BIGGS & MATHEWS ENVIRONMENTAL

August 26, 2014

Re: New Boston Landfill – Bowie County, Texas
MSW Permit No. 576C
Amendment Application – Supplementary Submittal
Tracking Nos. 17346969, 17469494, 18003368, & 18174035;
CN603572132; RN102594892

**DRAWING
D3.9**

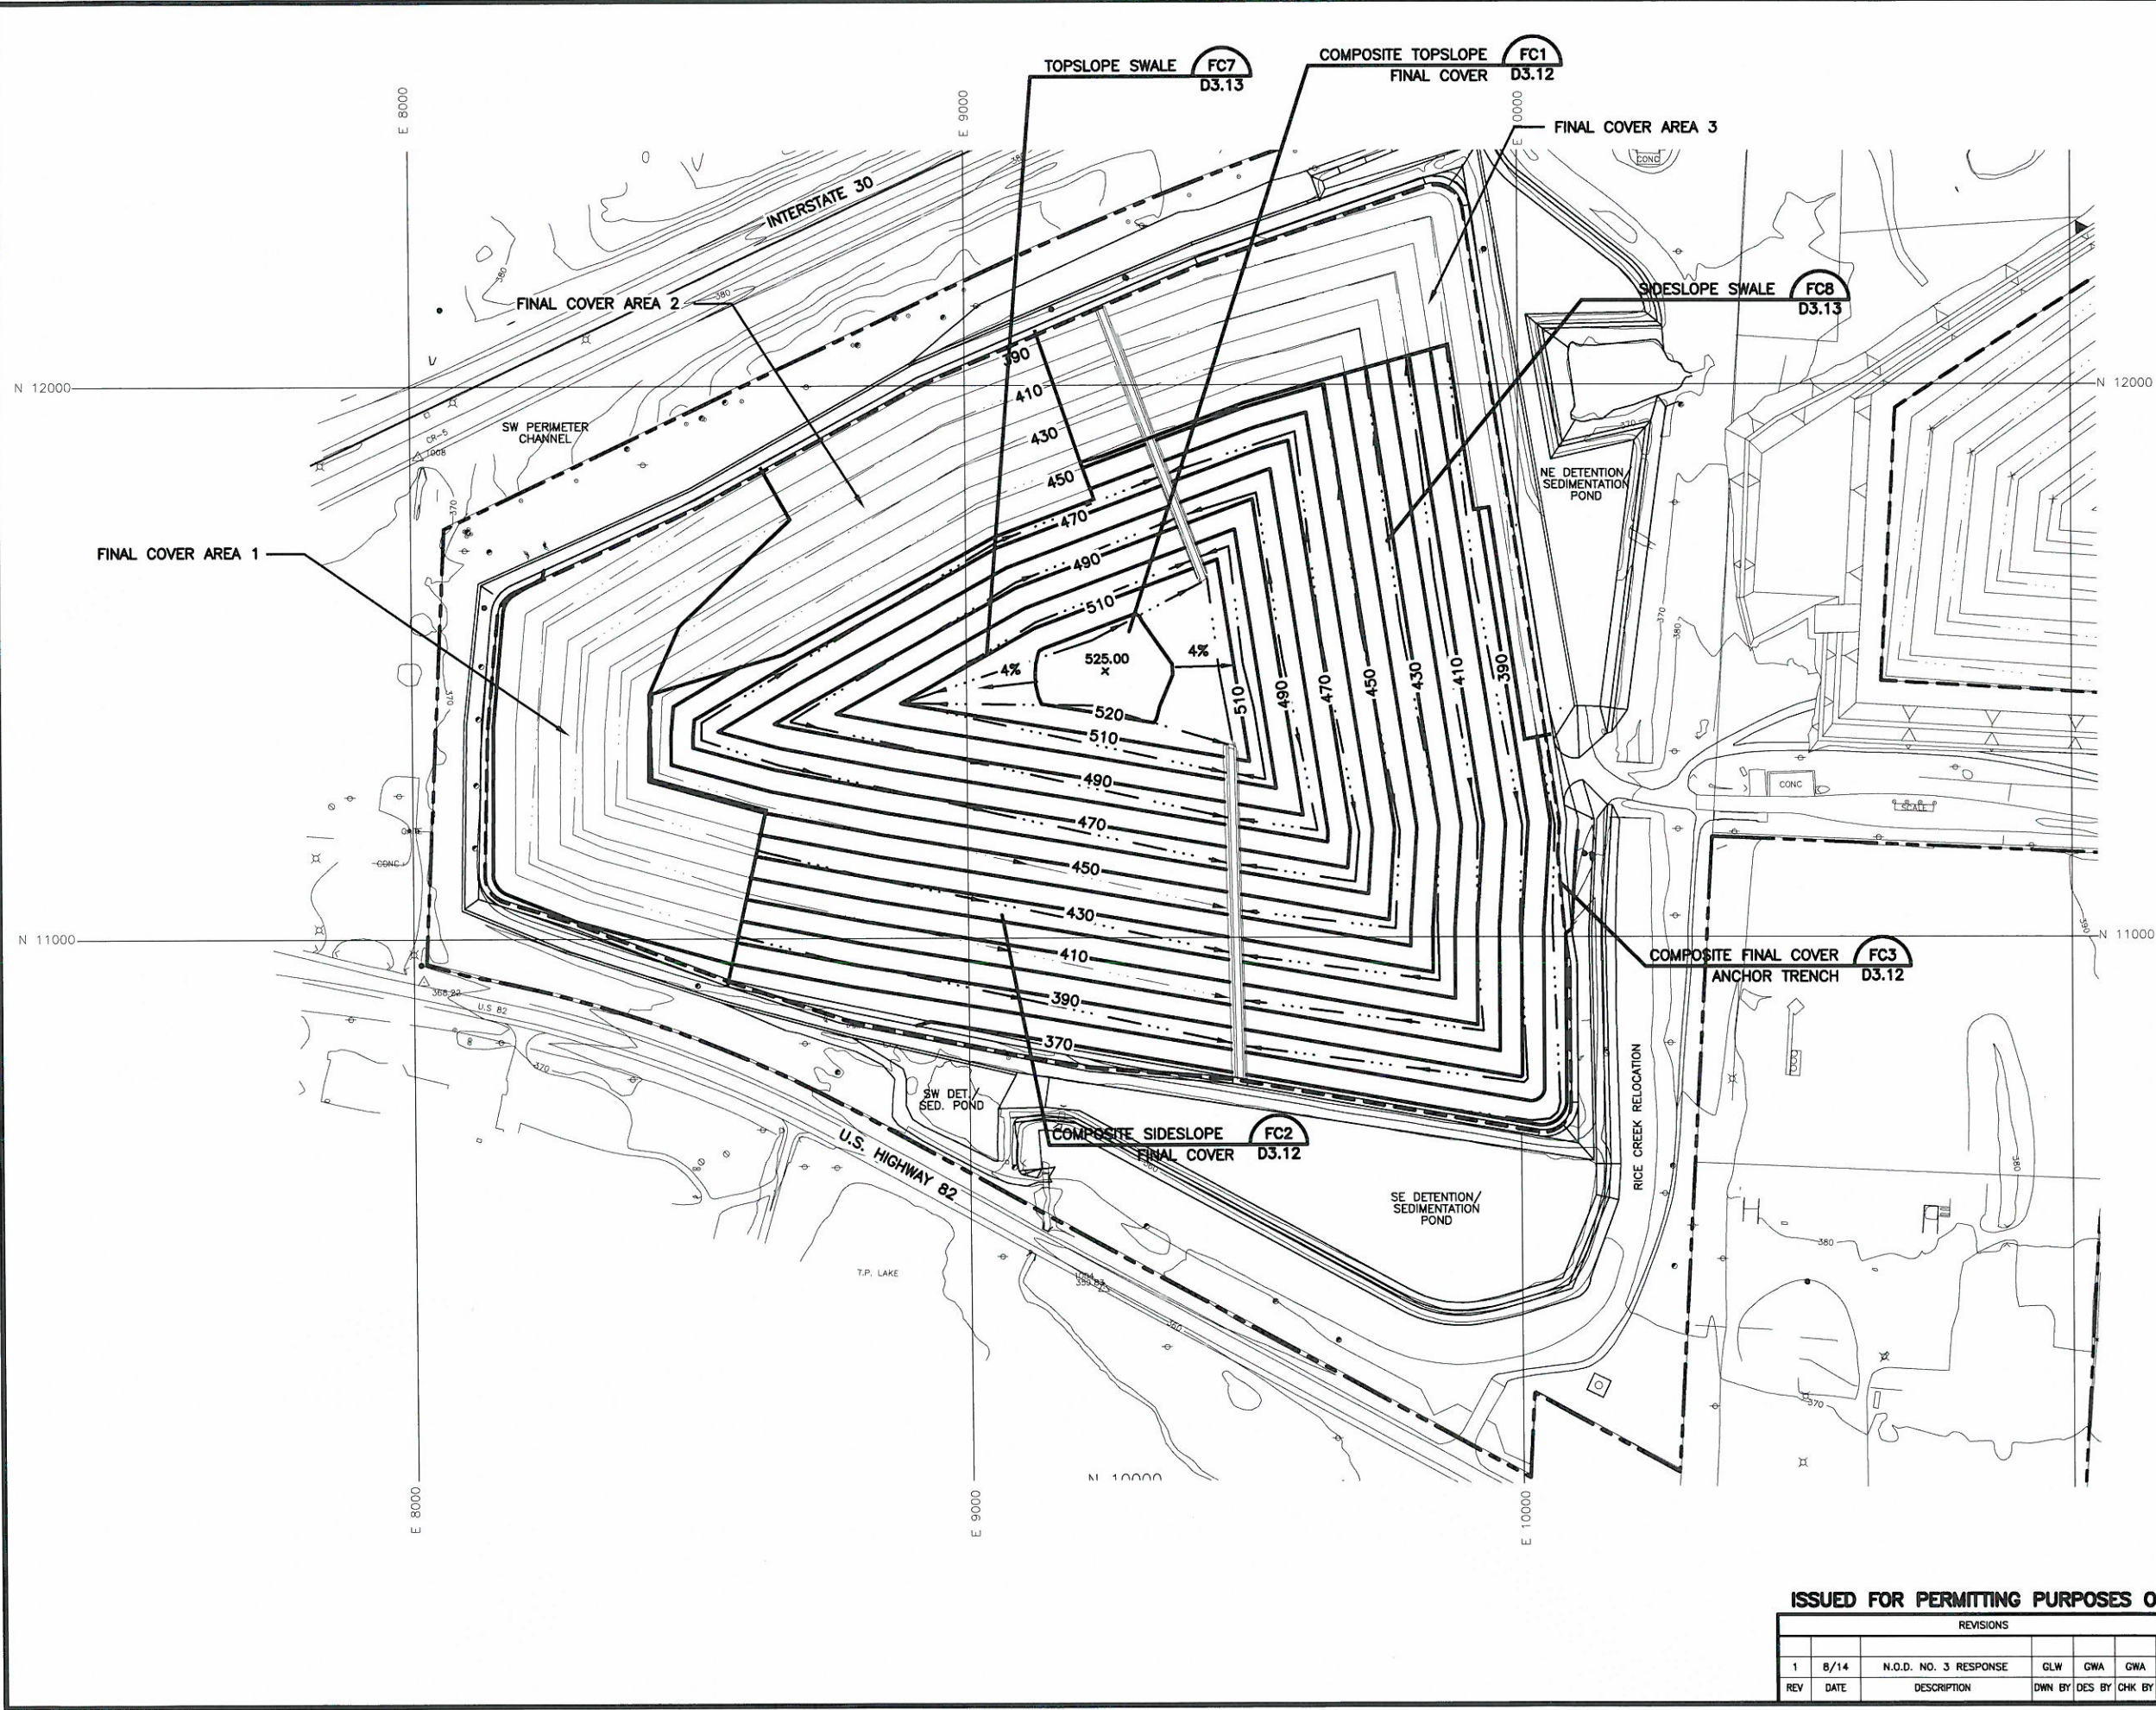
- Part I Form, Page 10, updated signature page.
- Attachment D1, Drawing D1.7, disregard the submitted revision. Drawing D1.7, dated July 8, 2013 is correct.
- Attachment D3, Drawing D3.9, revised to delete Note 4 regarding maximum elevation of waste.
- Attachment G, page G5-ii, corrected to show the addition of Section 2.8 and the renumbered Section 2.9.
- Attachment F3, page F3-6, corrected to show revised language as discussed.
